SJ50-04

S E R V I C E N O T E

Agilent SJ50 Series II Optical Board Test System

Cable Stress On Rear Hood Hinge

Figure 1

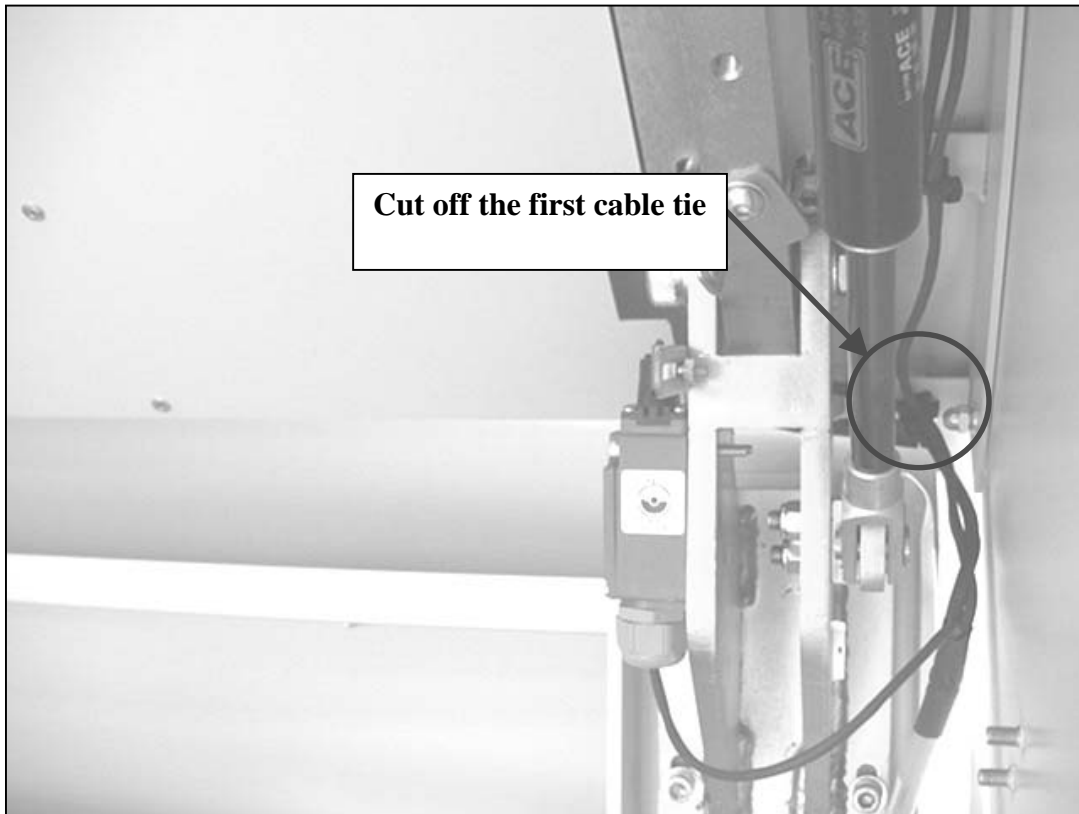
A cable on the SJ50 Series II System is being overly stressed when the Hood Assembly is opened and closed.

1. Cut off the cable tie on the first cable tie cleat.
The position is shown in **Figure 1**.

Figure 2

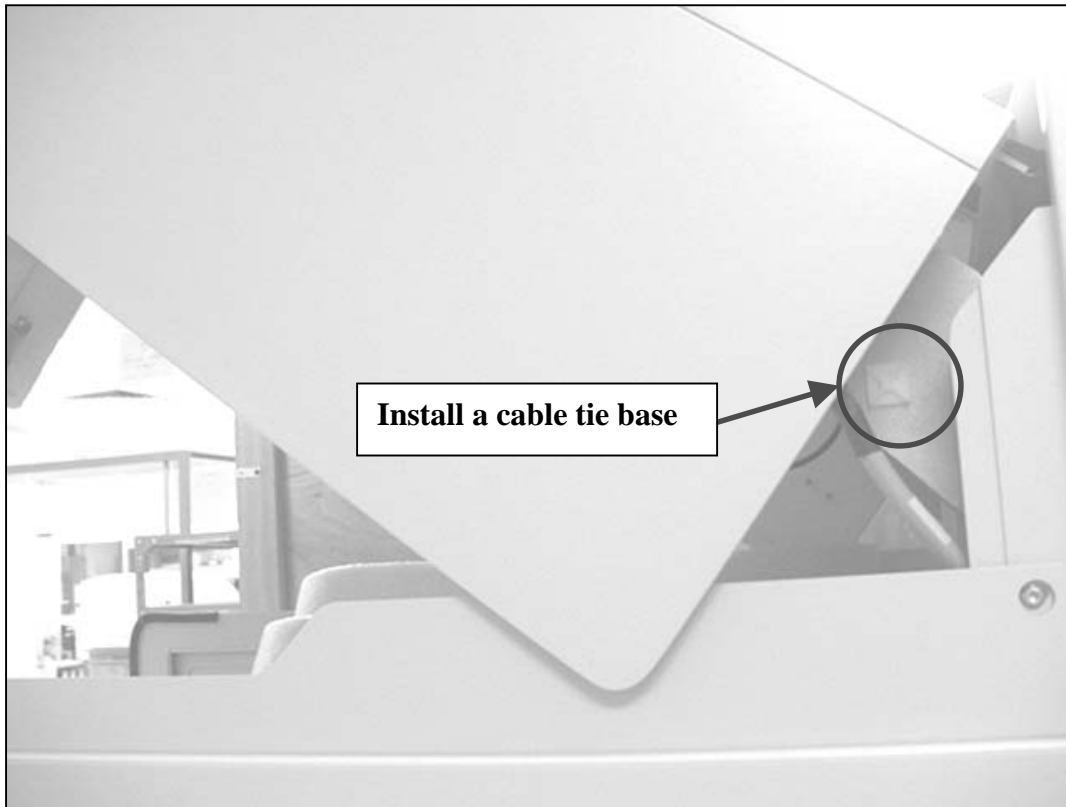
2. Clean the hinge to remove grease and place a cable tie base (5186-3981) on the hinge at the position shown in **Figure 2**.

Figure 3

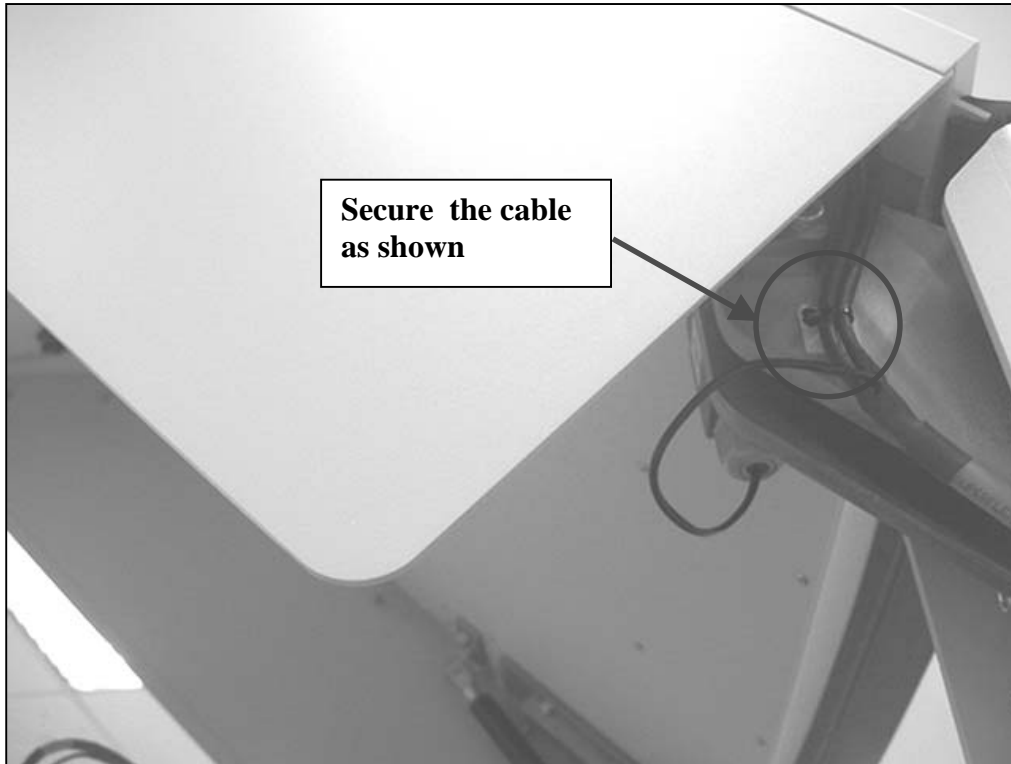
3. Use a cable tie (5186-1684) to secure the cable tie to the cable tie base shown in **Figure 3**.

Note: Ensure the hood cable is stress free when both the hood is in the closed and open position.
